**SERVICE INFORMATION BULLETIN**

**APPLICABILITY:** 2019MY Legacy and Outback  
 2019MY Impreza  
 2019MY Crosstrek  
 2019MY WRX  
 2019MY BRZ

**NUMBER:** 05-68-19

**SUBJECT:** Front Hub Retaining Bolt Change

**Identification for Bolts Used On SIA-Built Models (Legacy, Outback, Impreza, Ascent):**

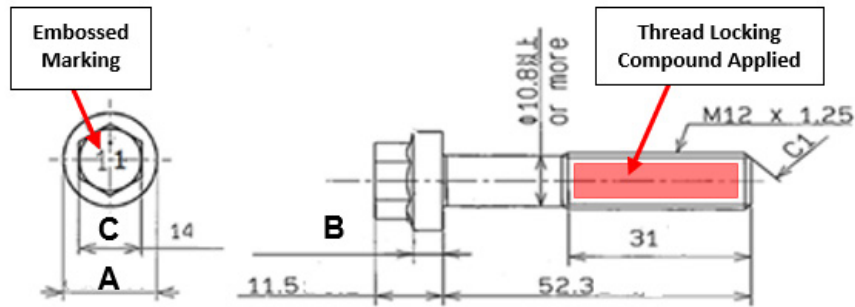
COMPARISON INFORMATION		New:	Old:
Part Number:		901000468	901000449
<b>A</b>	Flange Diameter (mm)	22.8	21
<b>B</b>	Flange Thickness	5	2.8
<b>C</b>	Width Across Flats	14	14
Embossed Marking		11	10
Thread Locking Compound Color		Red	Green

**Identification for Bolts Used On Japan (SBR) -Built Models (Crosstrek, WRX, BRZ):**

COMPARISON INFORMATION:	New:	Old:
Thread Locking Compound Color	Red	Green

**VERY IMPORTANT:** Due to the following torque specification change, these bolts should never be mixed to avoid an under/ over torque condition on any one or more bolts. Any remaining inventory of p.n. 901000449 should be scrapped.

- When replacing these bolts on a **SIA-Built** model (Legacy, Outback, Impreza, Ascent), the torque specification has been **CHANGED from 85 Nm (62.7 Ft. Lbs.) to 126 Nm (92.9 ft. lbs.)**.
- On **Japan-built** models (Crosstrek, WRX, BRZ), the torque specification remains **UNCHANGED, 95 NM (70.1 ft. lbs.)**.
